SAFETY EVALUATION SUMMARY

NPP TEMELIN COMPREHENSIVE SAFETY CASE REVISIT

**HIGH-ENERGY STEAM AND FEED WATER PIPELINES
AT THE 28.8M LEVEL
and
SAFETY AND RELIEF VALVES QUALIFICATION**

Prague - October 2002

Figure 3:

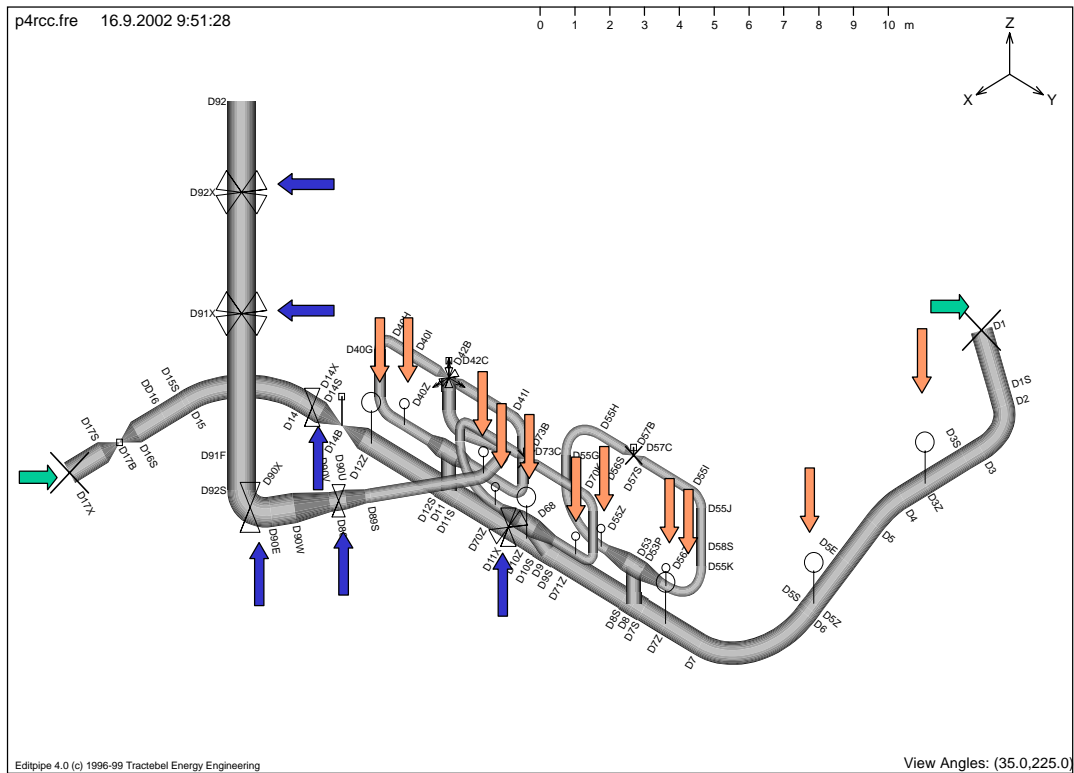
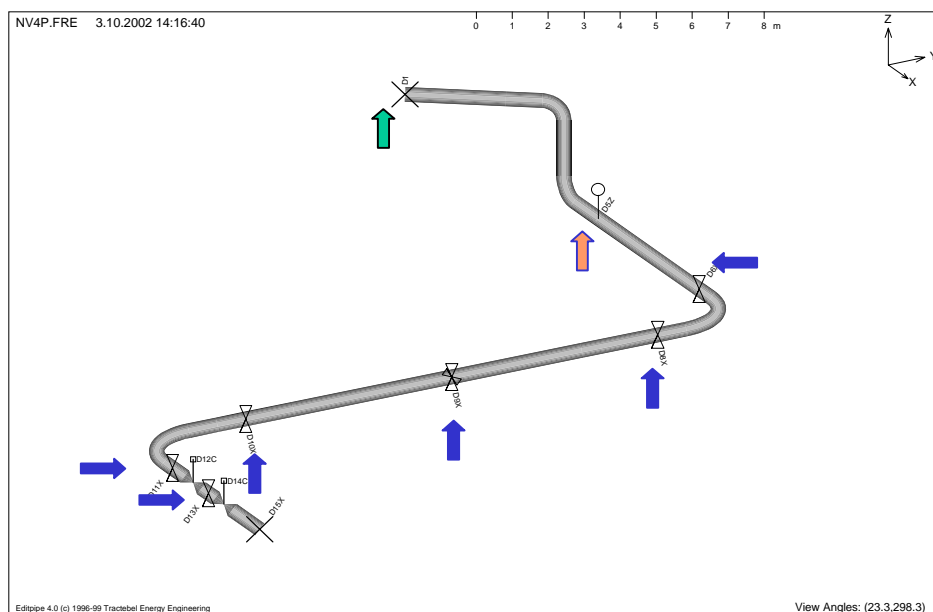
For the second level of protection the CSCR results propose application of the „no break zone/super-pipe" concept on the pipelines segment from containment penetration to anchoring supports – see Figure 3. Successful application of this concept provides for exclusion of sudden break in specified pipe segment if all prerequisites are in place. Feasibility of „no break zone/super-pipe" concept application is in the CSCR Final Report justified by following:

- Most conservative values of stresses calculated by the U.S.N.R.C. certified PIPESTRESS program are used;
- Thermal expansion results are evaluated. Displacement measurements confirmed validity of calculation model used ;
- Allowable values of stresses are determined using the lower bound curves from validated material properties database;
- Validated material database involves all used types of materials including weld material and welding consumables. The results also respect the influence of dynamic deformation ageing;
- Results of calculations performed by the PRAISE code show that the probability of a guillotine break (DEGB) for both the steam pipeline and feed water pipeline is lower than $10^{-10}/\text{ry}$, i.e. is extremely low.

SUJB accepts the concept of “no break zone/super-pipe” discussed above as second layer of protection against pipe break with the condition of completion examinations of all piping systems under consideration performed till the end of trial operation of individual units.

Figure 4: Scanner with probe holder on steam line

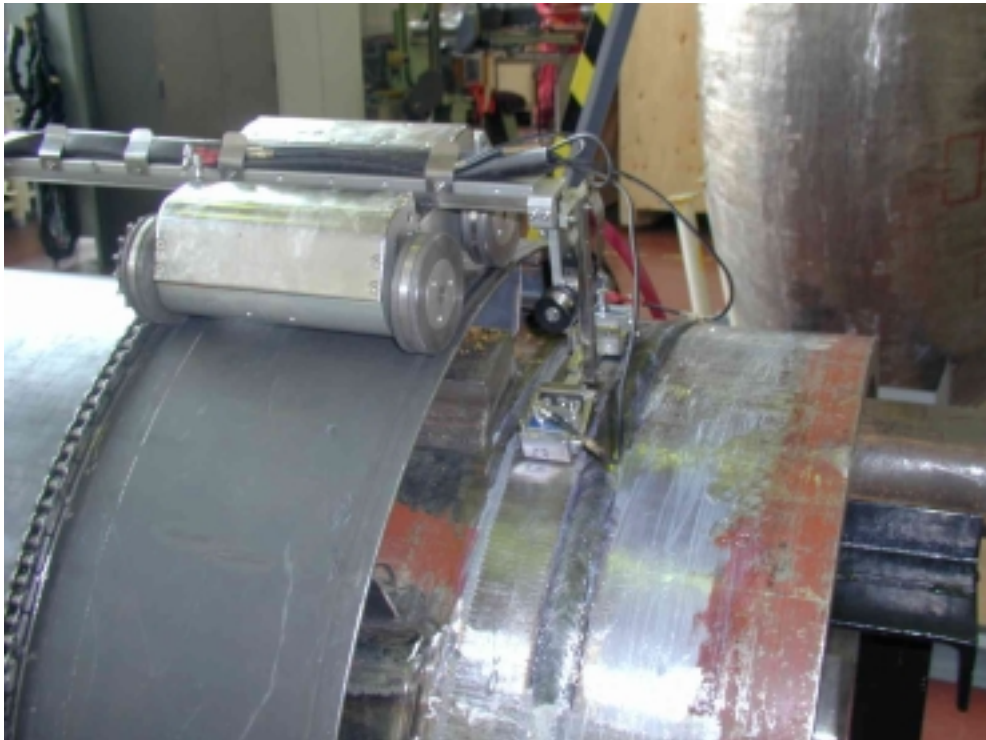
- 100 % volumetric UT method qualification file developed in compliance with best EU practice (ENIQ) – see Figure 4;
- Results of examinations performed with the use of this qualified method at unit 2 (all together 21 welds);
- Detailed plan for full steam line (TX70 code) inspection during the unit one refuelling outage at the beginning of 2003;
- Draft proposal for inspection plan of all remaining welds in both units.

Figure 5

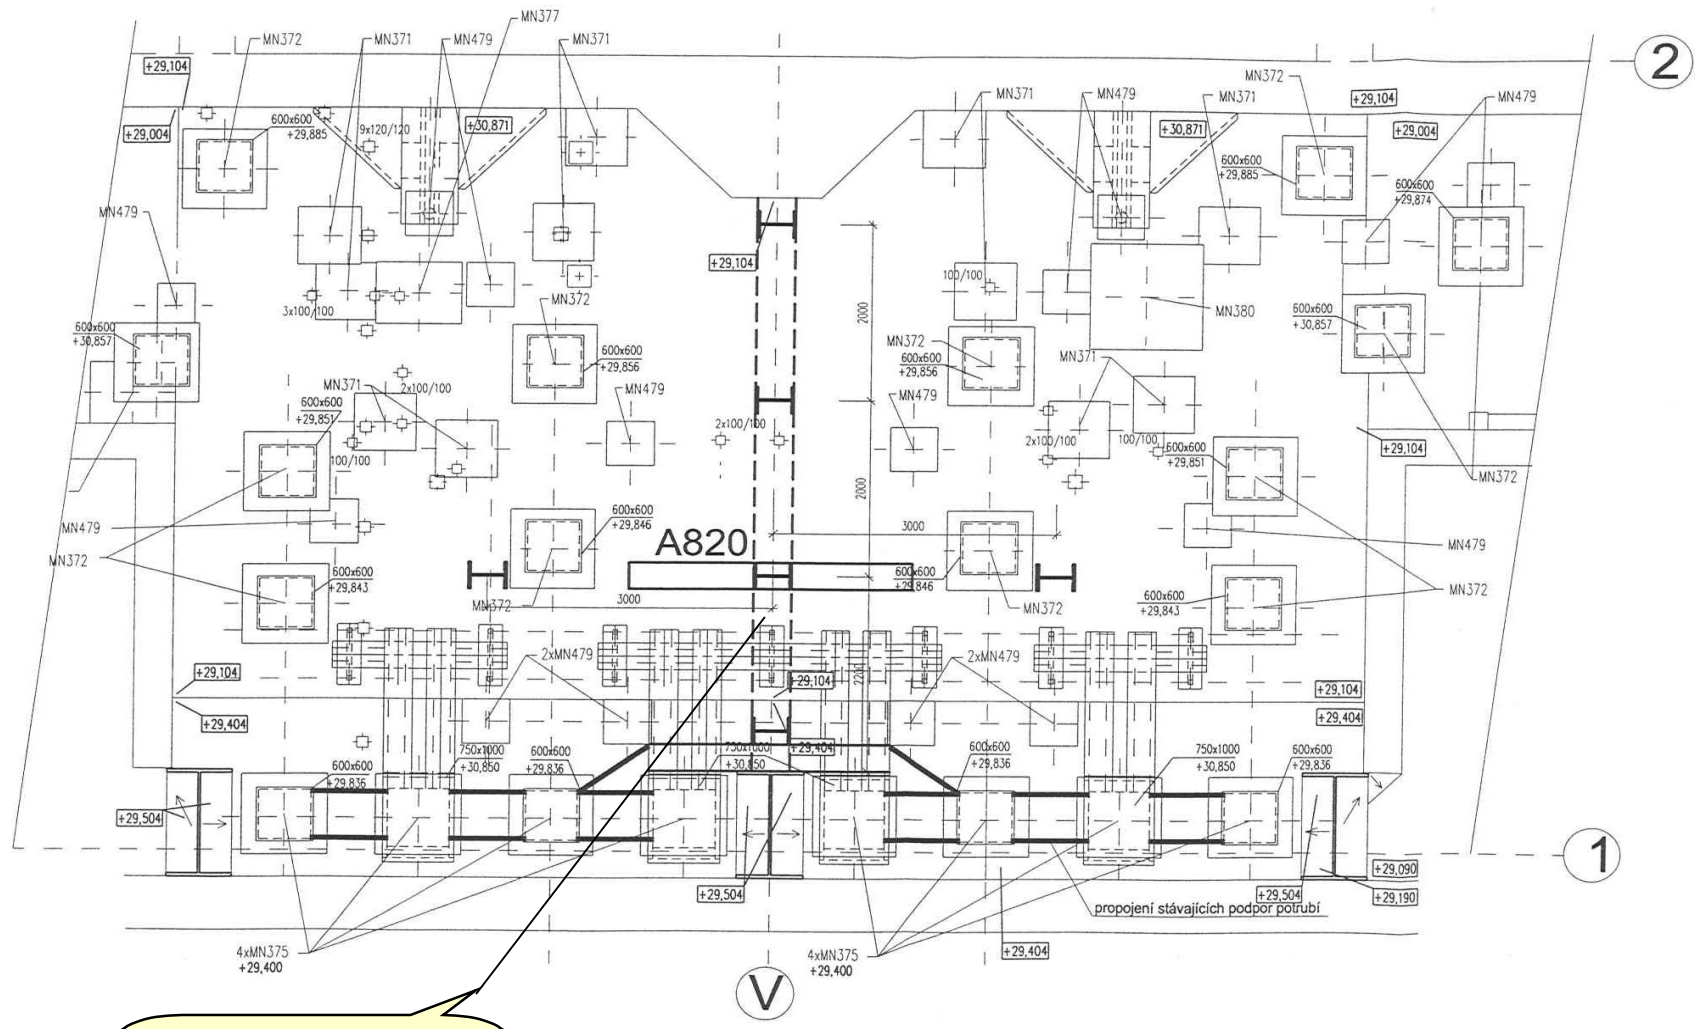
Qualified calculations of forces due to pipeline break induced dynamic effects are presented in the CSCR to allow for the feasibility study of the separating wall – for possible location see Figure 5. Analysis results prove that the wall can be supported and anchored in a way that it can transfer calculated dynamic effects. This level of protection is presented in the CSCR Final Report as reserve/redundant level of protection in case that combination of previously mentioned measures cannot be justified. On the other hand the report stress out that this solution is at limit from the safety benefit point of view, mainly due to possible prevailing negative effects in significant restriction of maintenance and in-service inspection work.

Based on safety assessment the SUJB do not consider incorporation of separation wall as a credible measure to be combined in order to protect consequential steam- and feed-water lines due to the pipe break for following reasons:

- Adverse effect for in-service inspection of safety-related components housed in discussed location;
- Above mentioned whip restraints, “no break zone/super-pipe” definition and periodic piping system monitoring offers justifiable combination of well-developed measures.
